Point Beach Nuclear Plant Units 1 and 2
Dockets 50-266 and 50-301
License Nos. DPR-24 and DPR-27

Response to Request for Additional Information:
Request For Exemption to 10 CFR 50, Appendix R (TAC Nos. MC2267 and MC2268)

RESPONSE TO REQUEST FOR ADDITIONAL INFORMATION REGARDING REQUEST FOR EXEMPTION TO 10 CFR 50, APPENDIX R POINT BEACH NUCLEAR PLANT UNITS 1 AND 2

ATTACHMENT 1
FIGURE 1
8' ELEVATION

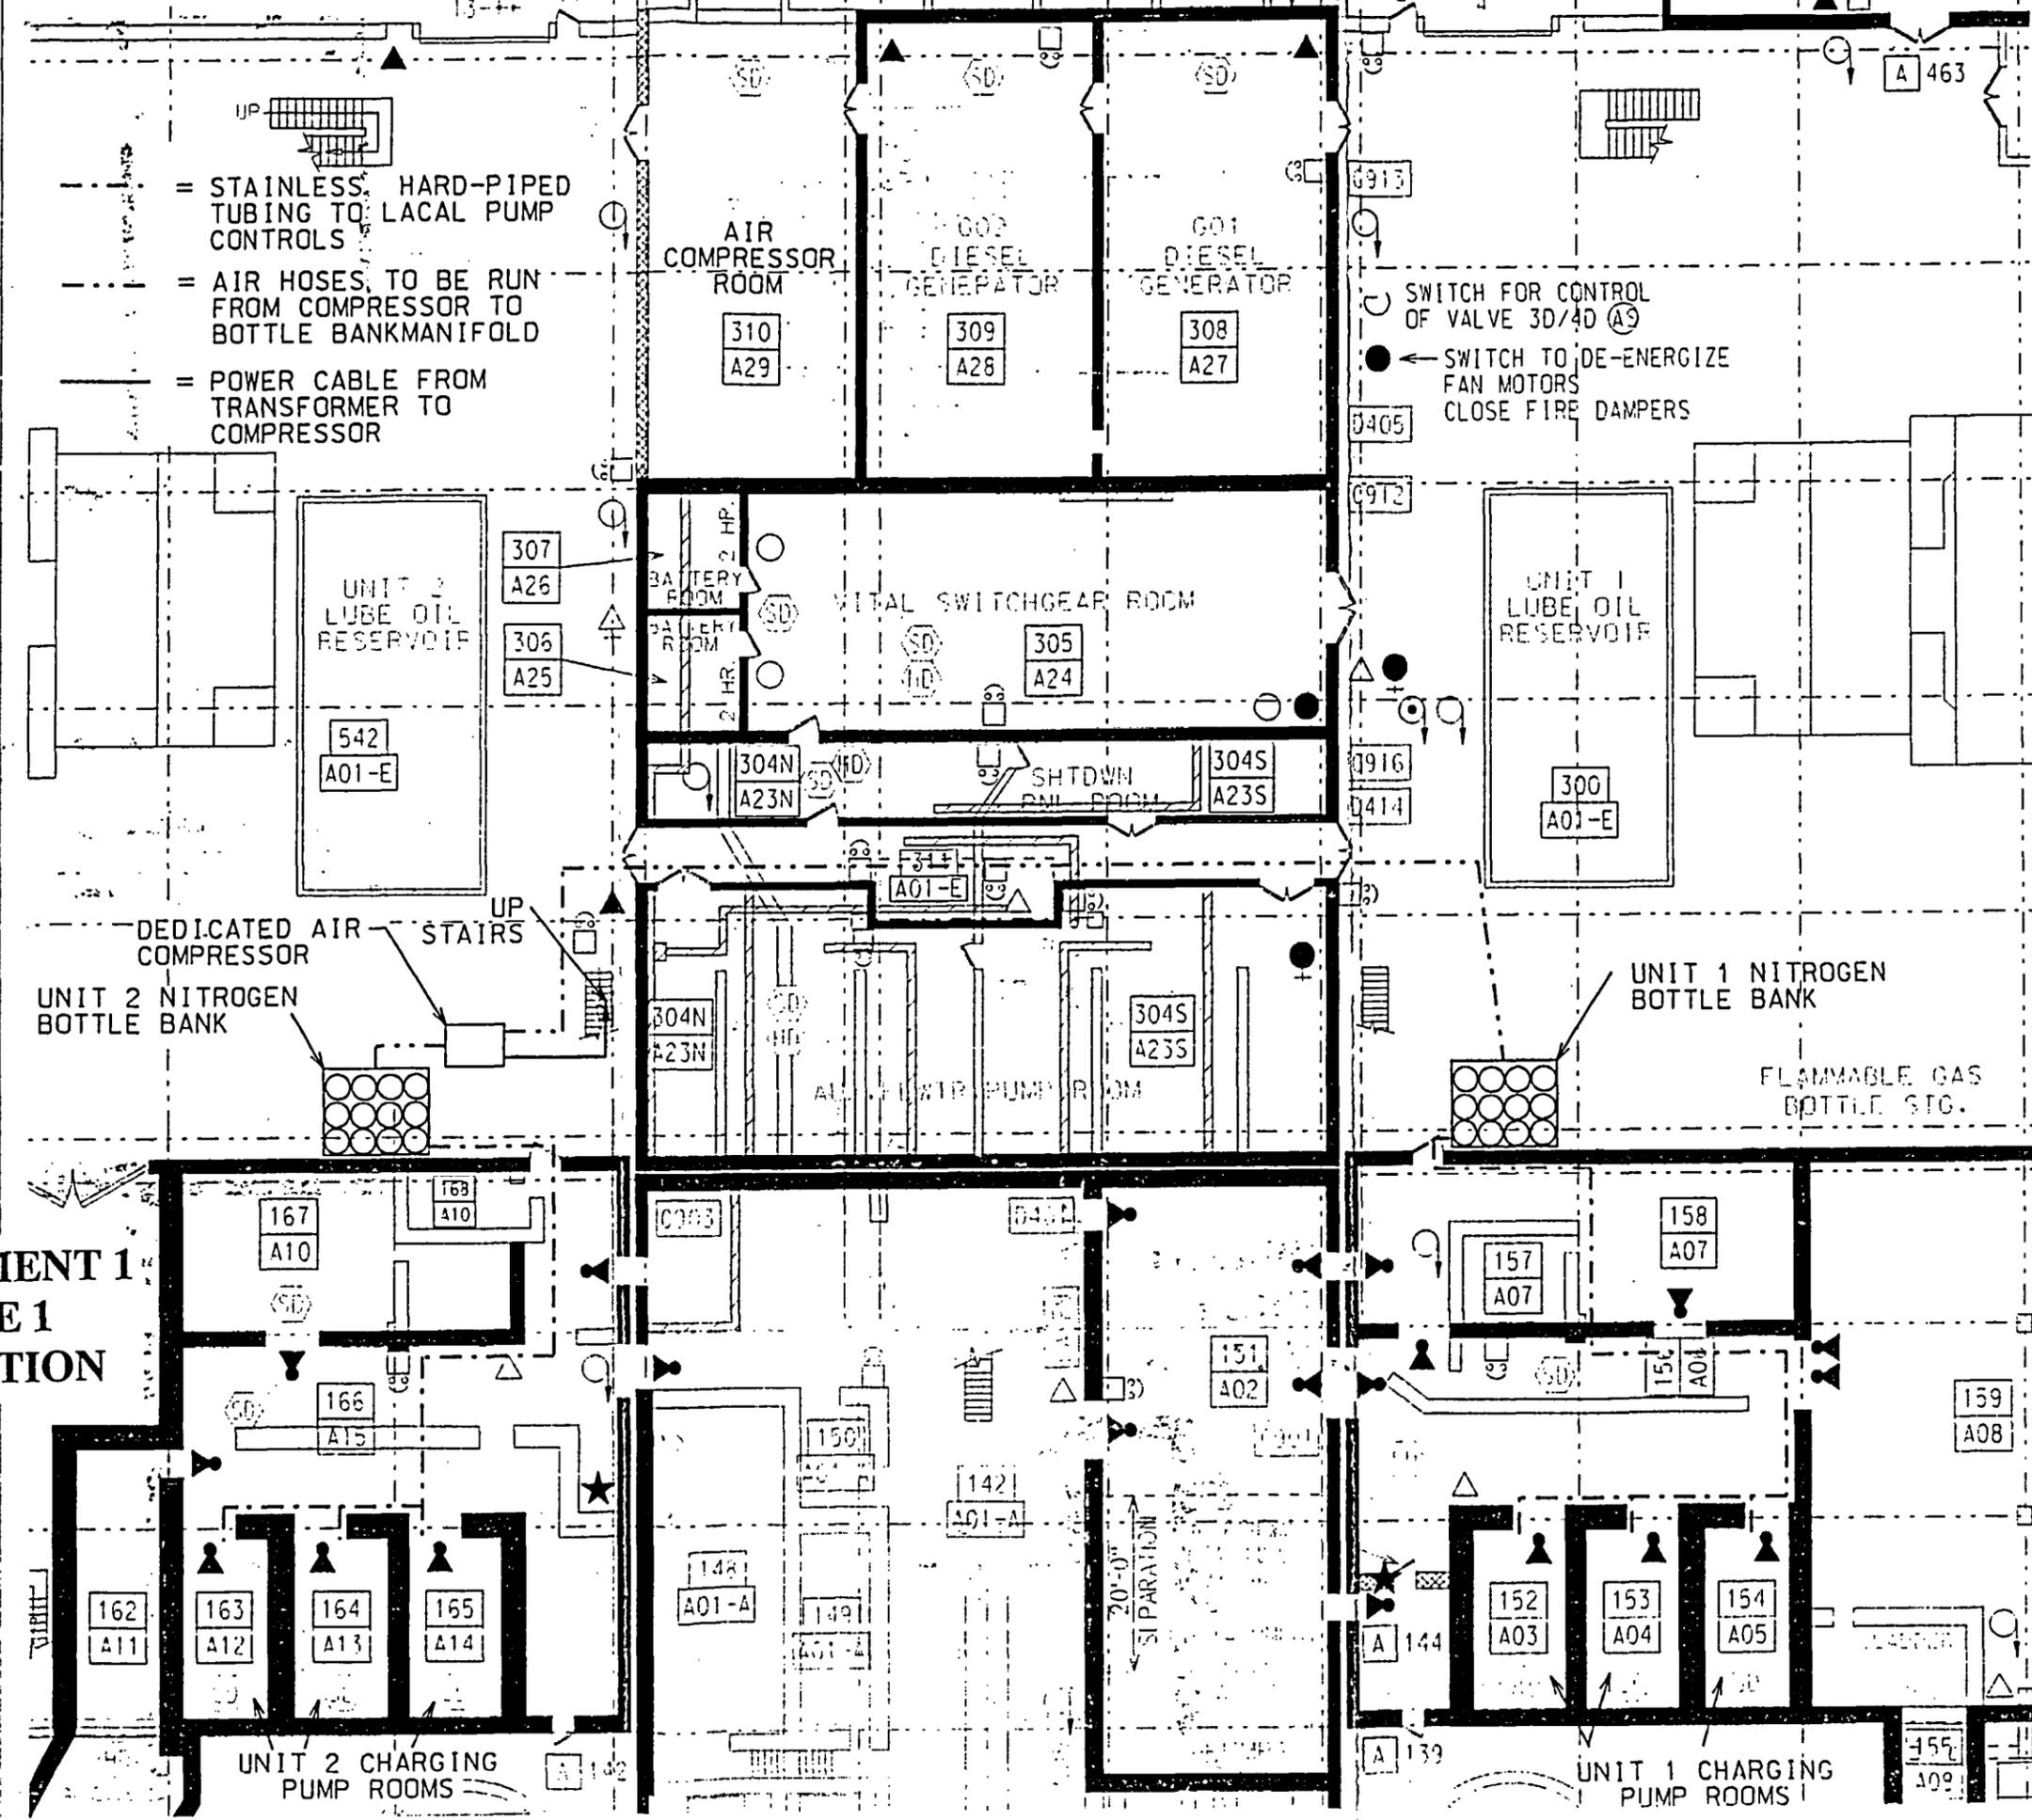
Please provide a graphical layout of the plant locations in question, including the charging pump room(s), the primary air compressor location(s), the backup N2 bottle manifolds, the dedicated air compressor, and the routes over which the electrical lines and pneumatic hoses would be laid out.

Where are the fire locations that would create the loss of primary air supply? How are they separated from the N2 bottled gas? How are they separated from the dedicated air compressor, electrical line, and hose storage locations?

- 8' level of the central Auxiliary Building (Area A01A shown in Figure 1 of Attachment 1),
- Pipeway #1 (Area A08 shown in Figure 1 of Attachment 1),
- Pipeway #4 (Area A11 shown in Figure 1 of Attachment 1),
- 2P2A Charging Pump Room (Area A14 shown in Figure 1 of Attachment 1),
- North Auxiliary Feed Water pump room (Area A23N shown in Figure 1 of Attachment 1),
- South Auxiliary Feed Water pump room (Area A23S shown in Figure 1 of Attachment 1),
- 4KV Vital Switchgear Room (Area A24 shown in Figure 1 of Attachment 1),

Figure 1 depicts the 8' (above lake level) elevation of the plant. Most of the equipment of concern is located on this figure. Near the upper left corner is the air compressor room containing all of the normal instrument and service air compressors. To the lower right and lower left are the six charging pump cubicles (three per unit) for Units 1 and 2, respectively. At left center are both the dedicated air compressor and the nitrogen bottle bank for Unit 2. The hoses for the compressor are stored in a metal storage box adjacent to the air compressor in the same fire zone. The power cords for the compressor are stored in a metal storage box on the 26' elevation of the Turbine Hall near the portable A-frame transformer (X-71). The nitrogen bottle bank for Unit 1 is shown at center right. The various hose and power cable routings are also depicted, as are the hard-piped tubing runs between the nitrogen bottle banks and the charging pump cubicles.

ATTACHMENT 2
FIGURE 1

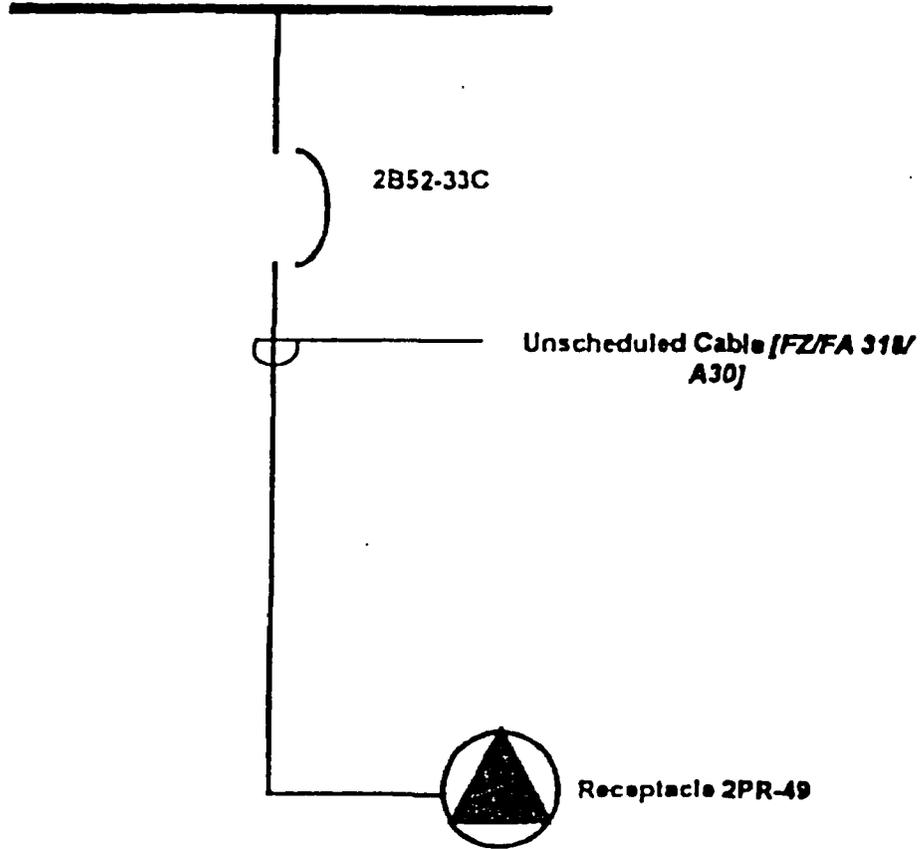
Discuss the proposed 480V electrical power supplies and the analysis that shows they are not subject to common mode power supply/enclosure failures with the primary air supply. Is there a fire that can cause the loss of primary air and the loss of the electrical supply to the dedicated air supply?

Attachment 2, Figures 1 and 2, show graphically the power scheme development for the two different power supplies, 2B-03 and B-08 (each a 480 VAC 3-phase welding receptacle) and illustrates that the power for these supplies derive from diverse sources.

Receptacle	Location	Fire Zone/Area	Power Supply
2PR-49	Cable Spreading Rm. (26')	318/A30	2B-03
PR-93	Turbine Bldg. (44')	547/A01-E	B-08/PP-70
